**Osewalt Setback Modification
File Number: 11-110690-LO**

**City of Bellevue
Development Services Department
Land Use Staff Report**

Proposal Description: Land Use review of a proposal to reduce the 75-foot toe-of-slope structure setback from steep slopes to 25-feet in order to construct a new single-family residence and associated improvements

Subject: Response to City of Bellevue Questions for Osewalt Property
3720 163rd Avenue SE
Bellevue, Washington

SITE PLAN

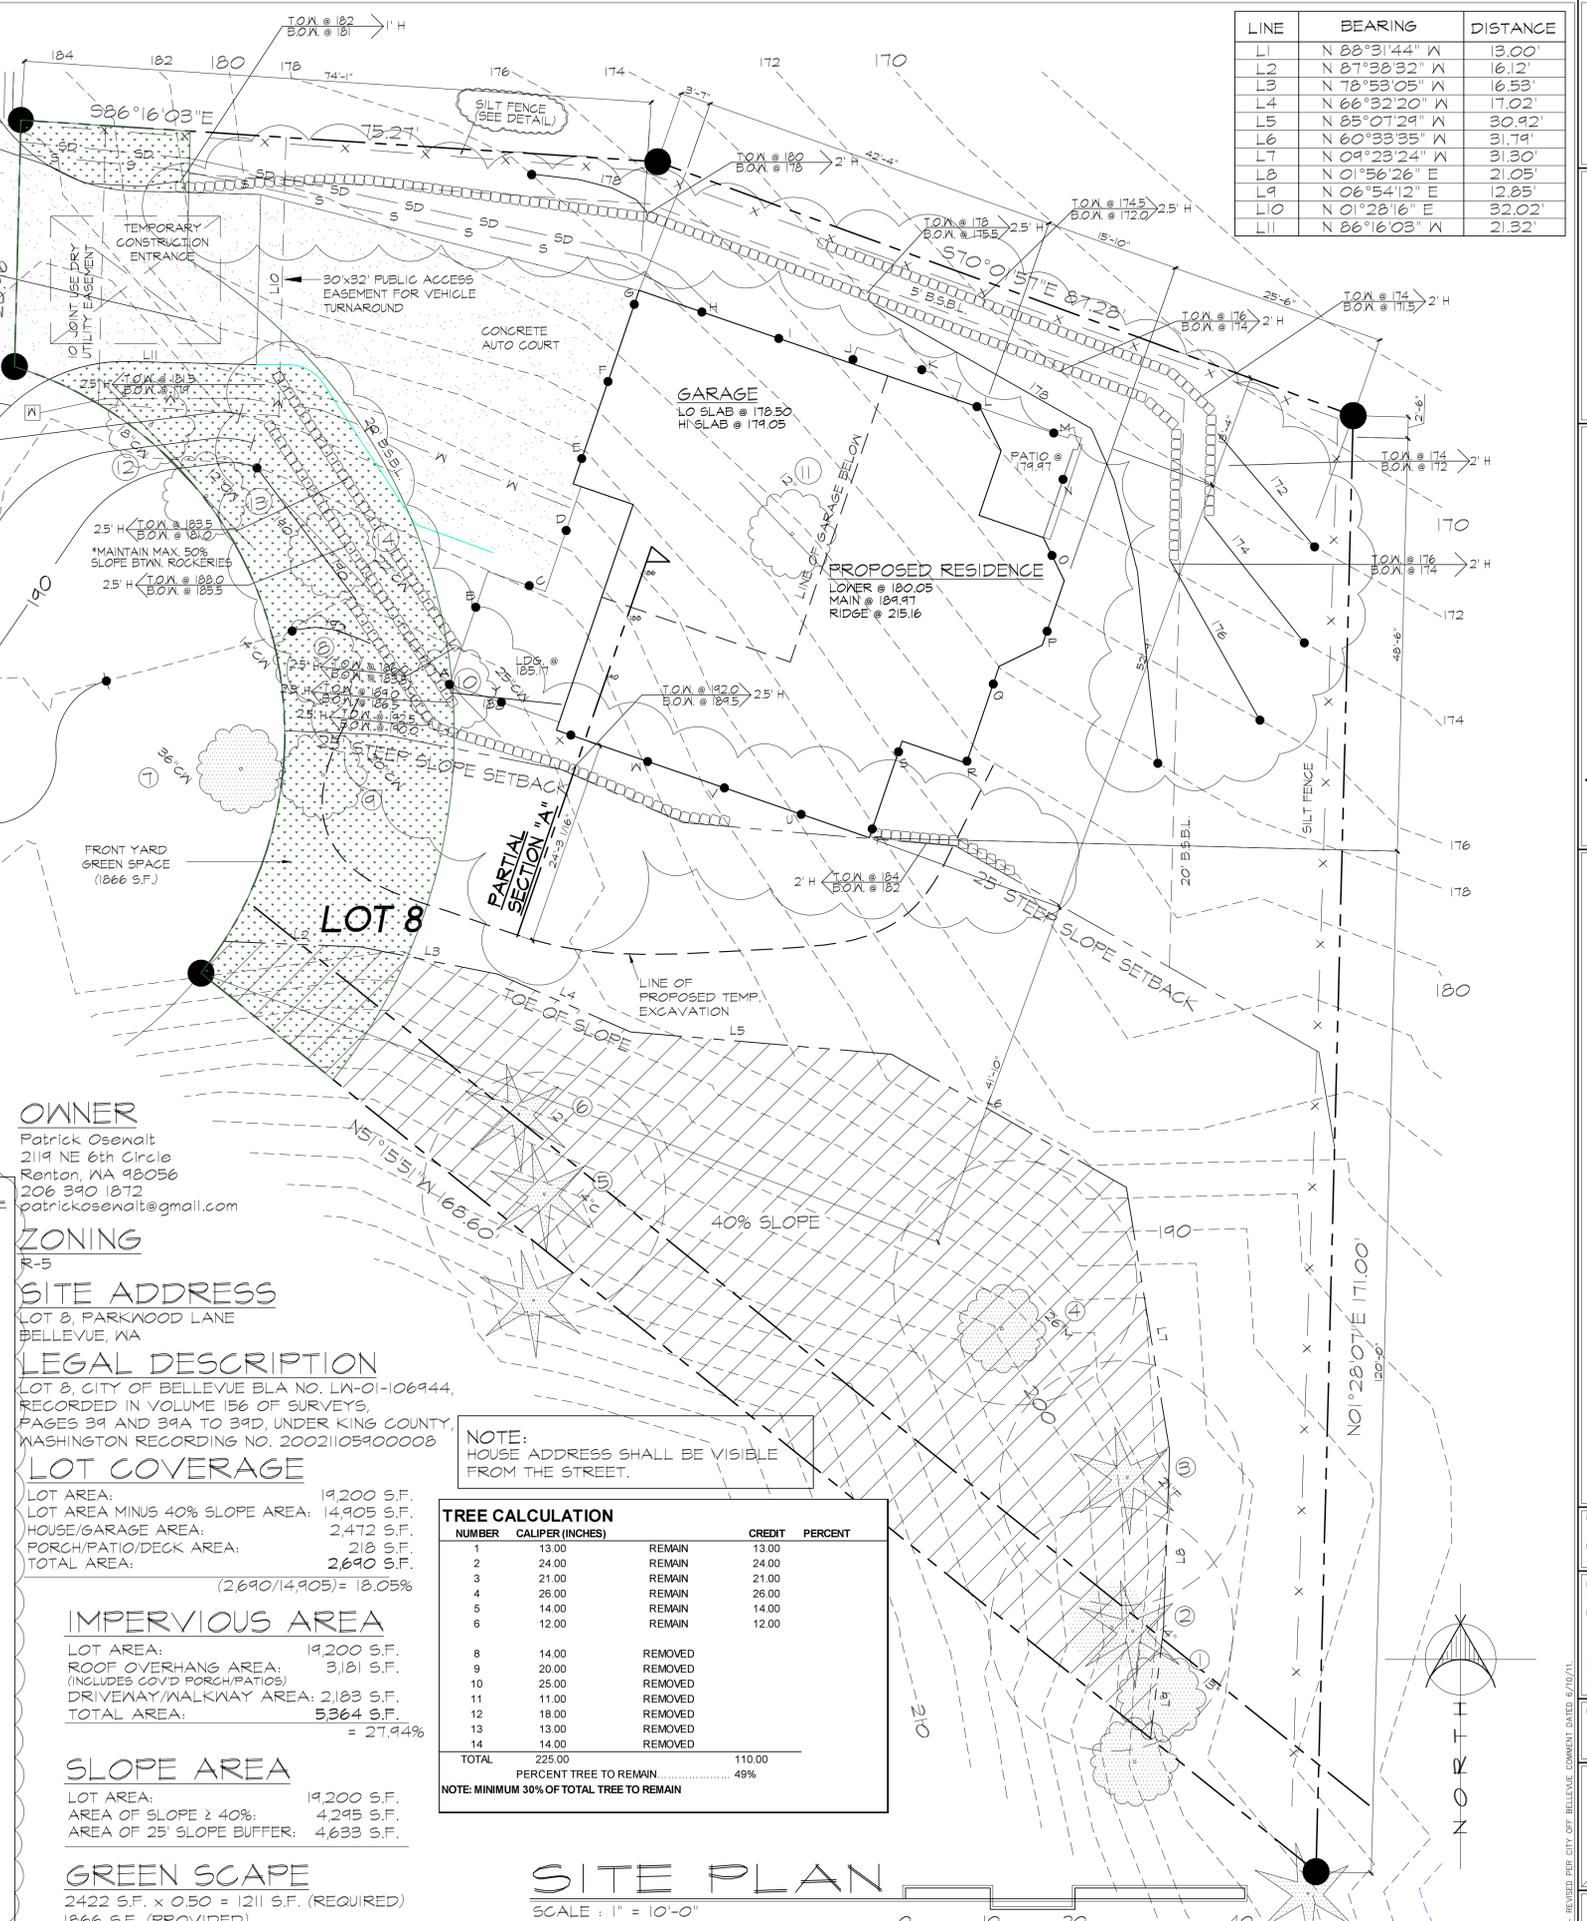
1. Provide a letter from the Geotechnical Engineer indicating that they have reviewed the plans and documents for this project and it is in compliance with the recommendations of the Geotechnical Report.

6. *Provide a section at the south foundation wall excavation showing temporary excavation slope and relationship between the 25 foot steep slope setback.*

8. *Provide a construction section of the rockeries and the drains behind them, on the plans as indicated in the geotechnical letter.*

Response: AESI has reviewed the revised sheet A0 forwarded by Architects NW on June 26, 2011. The sheet includes AESI's rockery detail, the temporary cut line and cross section view of the foundation cut requested by the City (see comments below). It is our opinion that this revised sheet combined with the previously reviewed sheets A1-A6, A10, A12, and S1 are in compliance with the recommendations in the Geotechnical Report.

Response: The revised plan sheet A0 shows the anticipated extent of the temporary cut based on the recommended 1.5H:1V (Horizontal:Vertical) inclination. This cut extends up to approximately 20 feet into the 25-foot-wide steep slope buffer. It is AESI's opinion that the cut, as shown, is suitable from a geotechnical standpoint and will not impact the steep slope area.

Response: The requested section and temporary cut line have been added to revised sheet A0. The cut line extends up to approximately 20 feet into the 25-foot steep slope setback.

Response: At section “A” the planned finish floor is at elevation 178.55 and existing grade is approximately elevation 191. With a footing set at 1.5 feet below finish floor, a cut depth of approximately 14 feet will be required. This proposed cut at the recommended 1.5H:1V inclination is acceptable to AESI.

Response: AESI’s rockery and drain detail have been added to revised sheet S0.

Attachment: Rockery Cross-Section Detail

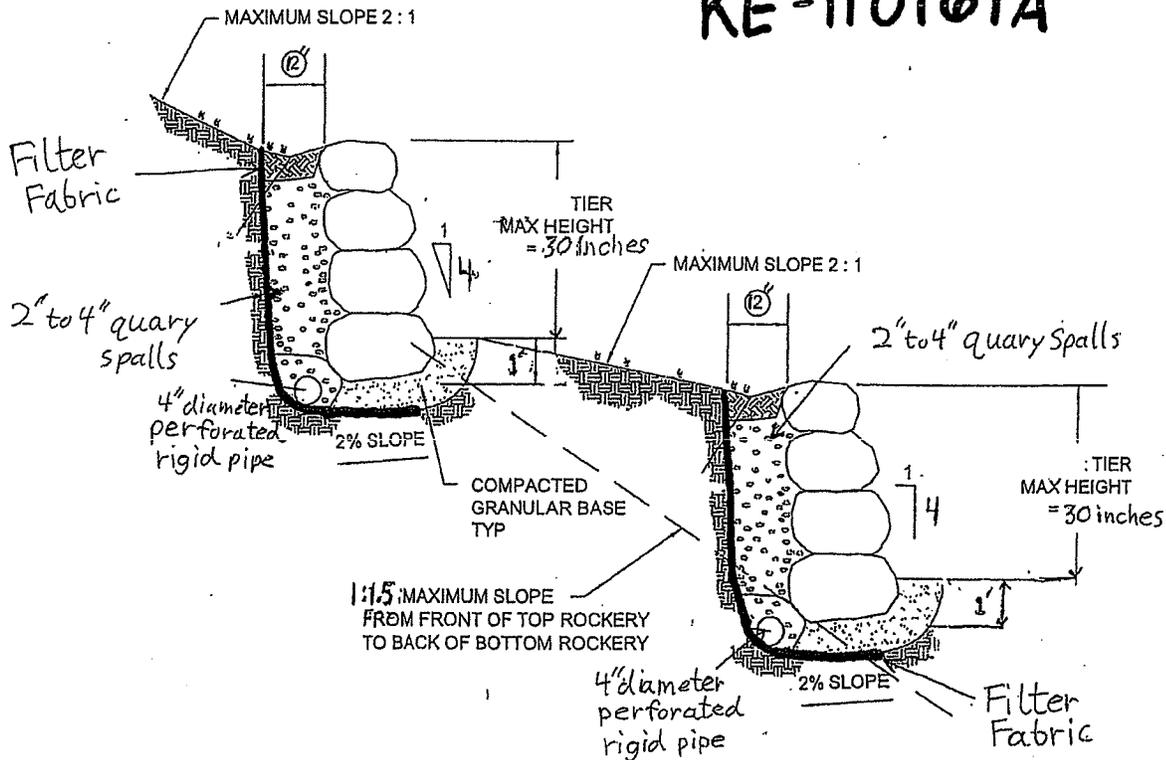
F. Where change in grade outside the building footprint is necessary, the site retention system should be stepped and regrading should be designed to minimize topographic modification. On slopes in excess of 40 percent, grading for yard area may be disallowed where inconsistent with this criteria;

Response: The plans show the use of tiered rockeries with heights of 30 inches or less stepping up the slope, with slopes between the rockeries of no more than 2H:1V, to mitigate modification of the slope conditions. The recommended cross-section detail for these tiered rockeries is attached to this comment response letter. On the northern side of the house a retaining wall is planned. This wall will to be approximately 4 feet high and will not significantly alter the natural slope conditions. No slope modifications are planned on the marked steep slope area or within the 25-foot buffer zone.

- 1.) Rockeries shall be constructed using 3 man rocks.
- 2.) Rockeries must be installed with drains sloping to Storm Drain system. Filter fabric (Mirafi 140N or equivalent) should be placed against the cut face behind the 2-4" quarry spalls
- 3.) All subgrade and slope soil shall be compacted to at least 90% of Modified Proctor (ASTM:D 1557).
- 4.) Geotechnical inspections shall be required for rockery subgrade, drainage and soil compaction
